COMMONWEALTH EDISON COMPANY
Byron/Braidwood - Units 1 & 2
Project Nos.: 4391/4392/4683/4684

Moisture Content Analysis
For The Air Stream
At The Inlet To Auxiliary Building
Ventilation Exhaust Charcoal Filters

NRC QUESTIONS REGARDING

FIGURE 2-1 MOISTURE REMOVAL EFFECTIVENESS FOR
RHR PUMP CUBICLE AREA COOLER
($R = 9$)

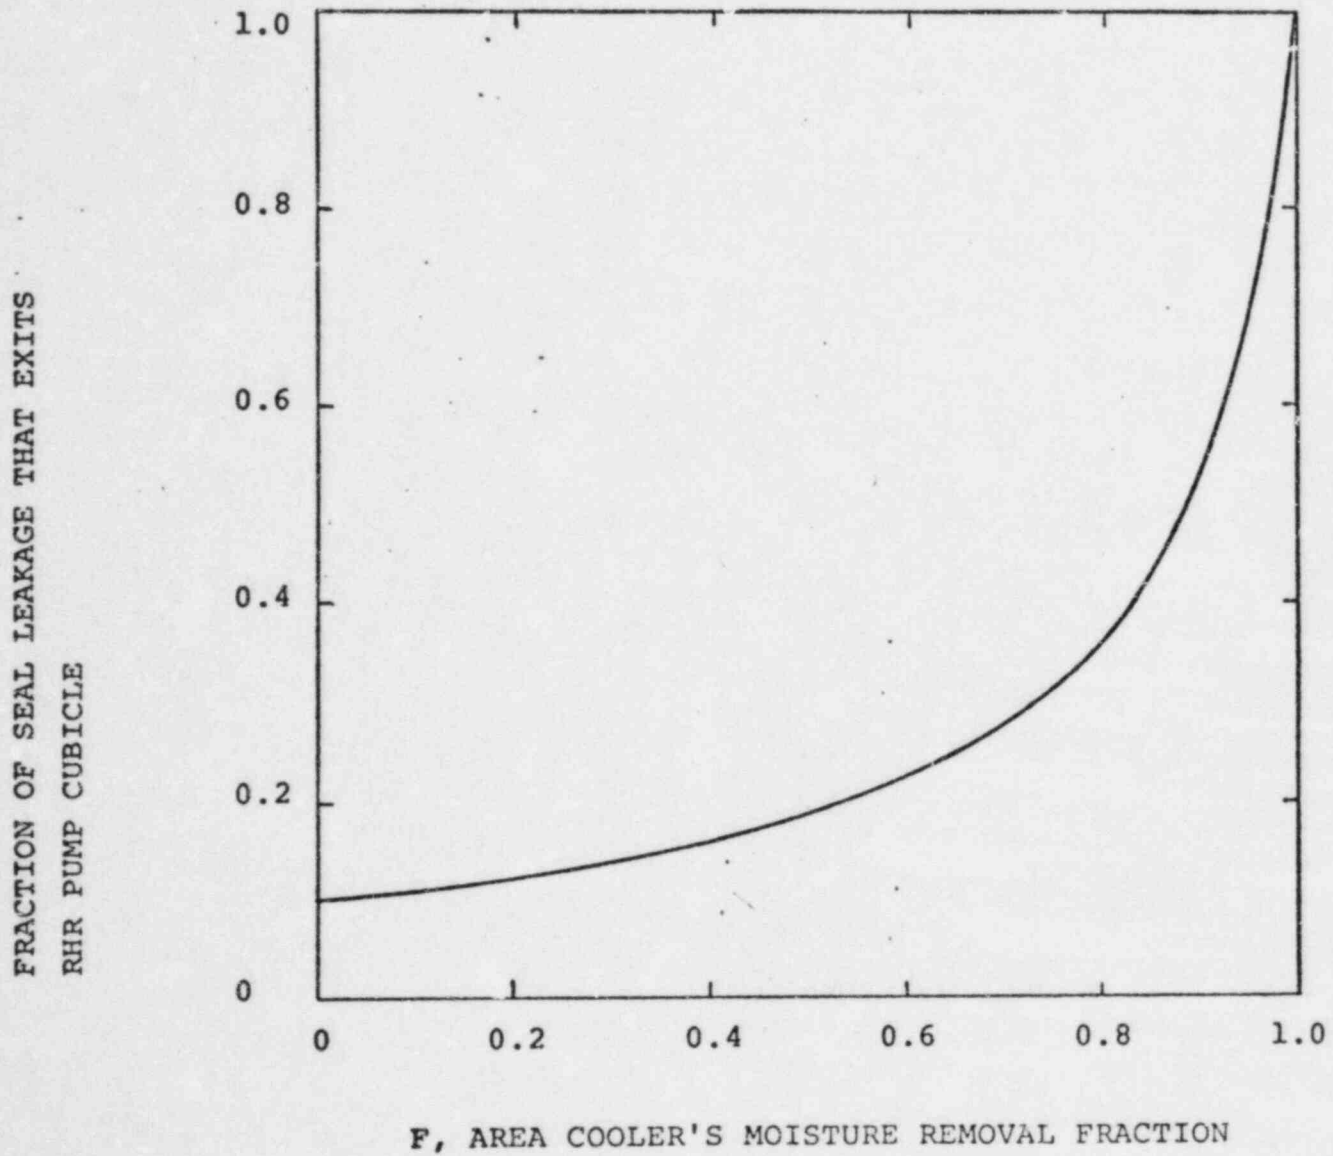
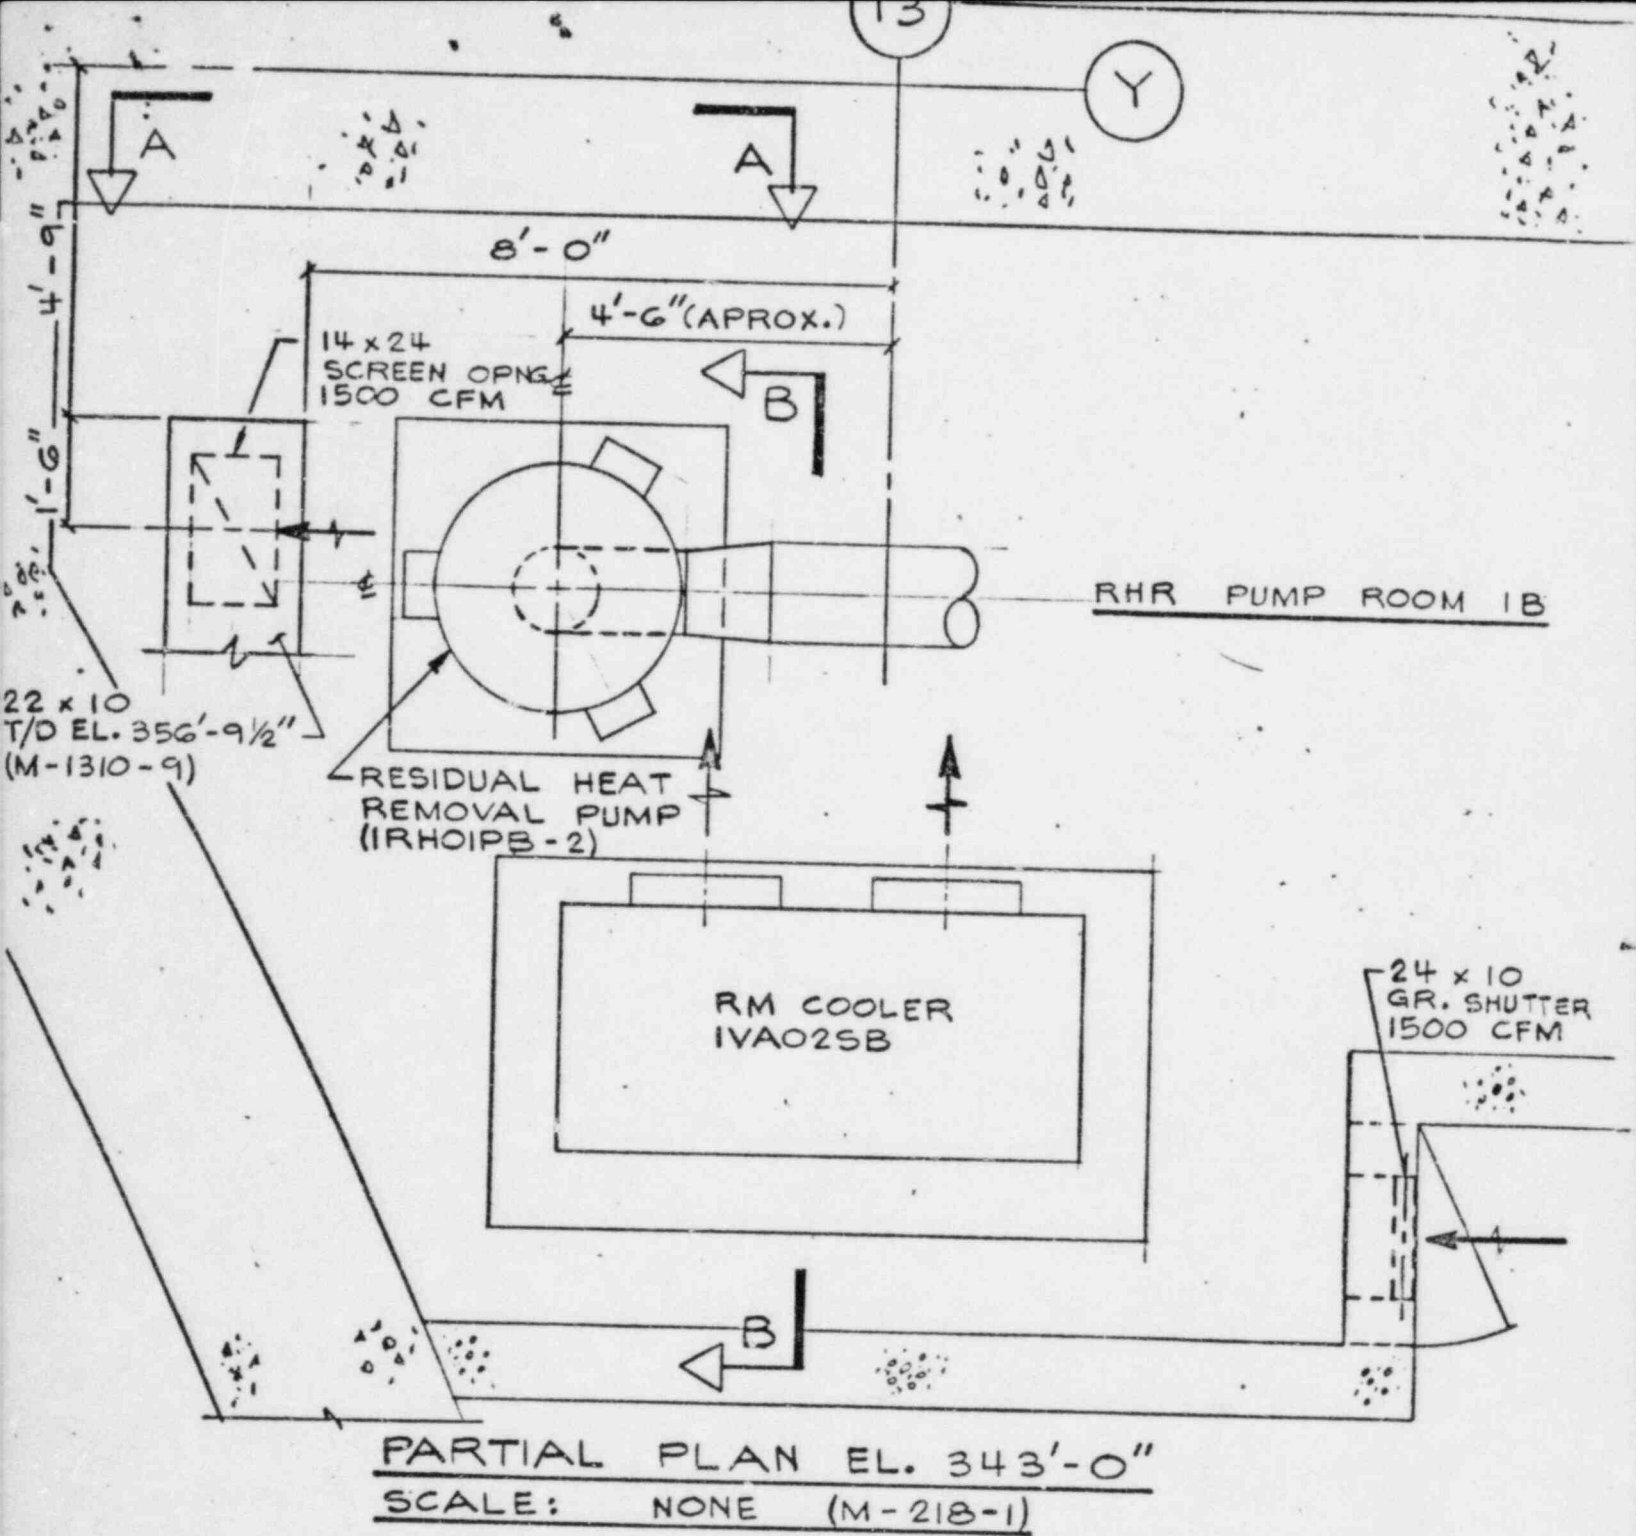
Paragraph IV.C of the analysis stated that it is assumed that all the leakage that does not flash is removed from the pump cubicle by the floor drain system. We believe this assumption is non-conservative. Revise the analysis to include a conservative assumption for vapor from a seal failure (e.g. 20%)

Figure 2-1 displays Equation 4 as a function of F, the area cooler removal fraction, and for a value of R=9 (10,154 cfm/1076 cfm).

Due to the internal configuration of the area cooler, all of the entrained moisture in its inlet stream is removed. Therefore, F is taken as zero (i.e., $H_2 = 0$), and Equation 4 states that only 10% of the seal failure moisture exits the RHR pump cubicle.

Additionally, the area cooler will condense water vapor and remove moisture by that mechanism as well. Thus, if 90% of the moisture is removed, then only 2% of the 20% suggested in Question 2 would remain. This is less than the 4% used in the reported analysis.

PLAN VIEW OF
RHR PUMP,
CUBICLE COOLER
& ASSOCIATED DUCT WORK

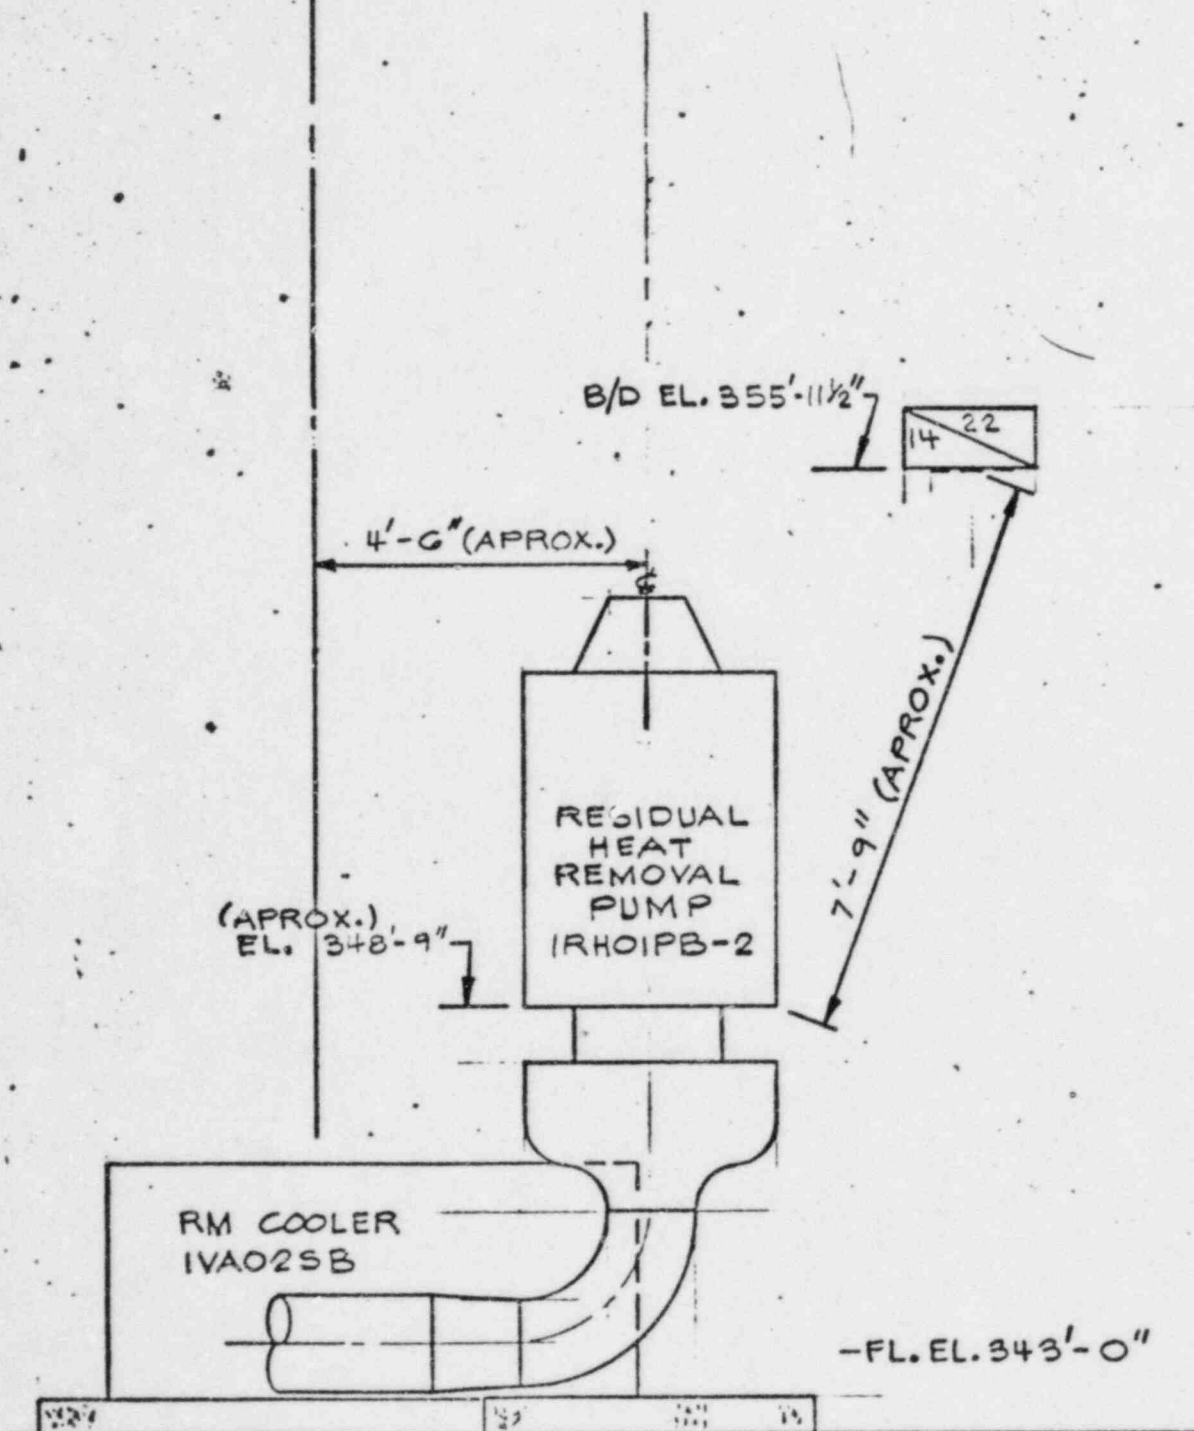
If, as a result of incorporating the comments in Question 2, you decide to include the effects of the area cooler, additional information concerning the cooler and its orientation with respect to the exhaust duct must be provided.

The attached sketches describe the location of the cubicle area cooler's suction and exhaust, the location of the ventilation exhaust inlet and the RHR pump and motor configuration. The proposed seal leakage would be at least 7'-9" away from the ventilation exhaust duct simply due to the elevation difference. Additionally, the RHR pump motor is located above the RHR pump seal and below the ventilation exhaust duct. The RHR pump motor, therefore, acts as a physical barrier. This physical barrier will inhibit spray from the proposed seal failure from directly impinging on the HVAC ducted exhaust screened opening.
